Access Compliance Report

Public Rights-of-Way

(Curb Ramps)

Intersection ID: 45130	Main Street: DULIN_CREEK_BV	Cross Street: PLAZA_RD_EXT	Location: NE
ADA ID: 4E54ACC5B613	Ramp Type: Combination1	Initial Pass/Fail: Fail	Overall Compliance: No
			Severity Score: 31.25

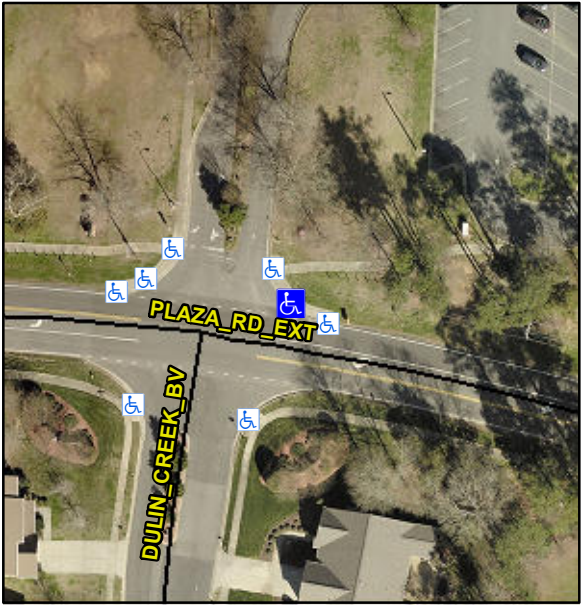
Codes/Mitigation Info/Possible Solution			Field Measurements/Component Compliance		
	Possible Solutions:		Compliance	Description	Data
	Remove & Replace Entire Ramp.		N/A	Ramp Length LT (in)	59.0
			No	Ramp Width LT (in)	35.5
			No	Ramp Slope LT (%)	9.2
			No	Ramp XSlope LT (%)	3.0
			N/A	Ramp Length (in)	24.0
			Yes	Ramp Width (in)	48.0
			N/A	Flare Type LT	N/A
			N/A	Flare Slope LT (%)	N/A
			N/A	Flare Traversable LT?	N/A
<p>Surveyor Notes:</p> <p>N/A</p> <p>PROW/ADA:</p> <p>Not Found, R304.5.1, R304.5.3, R304.3.2</p>			N/A	Ramp Slope RT (%)	7.3
			No	Ramp XSlope RT (%)	2.1
			Yes	Ramp Slope (%)	4.3
			No	Ramp XSlope (%)	2.5
			N/A	Flare Type RT	N/A
			N/A	Flare Slope RT (%)	N/A
			N/A	Flare Traversable RT?	N/A
			N/A	DWS Provided?	N/A
			N/A	DWS Contrast?	N/A
			N/A	DWS Length (in)	N/A
			N/A	DWS Full Width?	N/A
			N/A	DWS Offset (in)	N/A
			N/A	Shared Landing?	N/A
			N/A	Gutter Ponding?	N/A
			N/A	Gutter Lip Ht (in)	N/A

N/A	Painted X Walk1?	No
				X Walk 1 Direction	To S
				X Walk 1 Width (in)	N/A
				X Walk 1 Slope (%)	3.3
				X Walk 1 X Slope (%)	0.8
			N/A	Ramp inside XWalk1?	N/A
				Road Slope (%)	N/A
				Road X Slope (%)	N/A
			N/A	Ramp inside XWalk2?	N/A
				Clear Space?	N/A
			N/A	Clear Space to XWalk (in)	N/A
			N/A	Any Obstruction?	N/A
				Obstruction Type	N/A
					N/A
			N/A	Storm Grate/Utility Hazard?	N/A
				Storm Grate/Utility Type	N/A
			Yes	Surface Condition? (G/P)	Good
				Curb Slope (%)	21.6
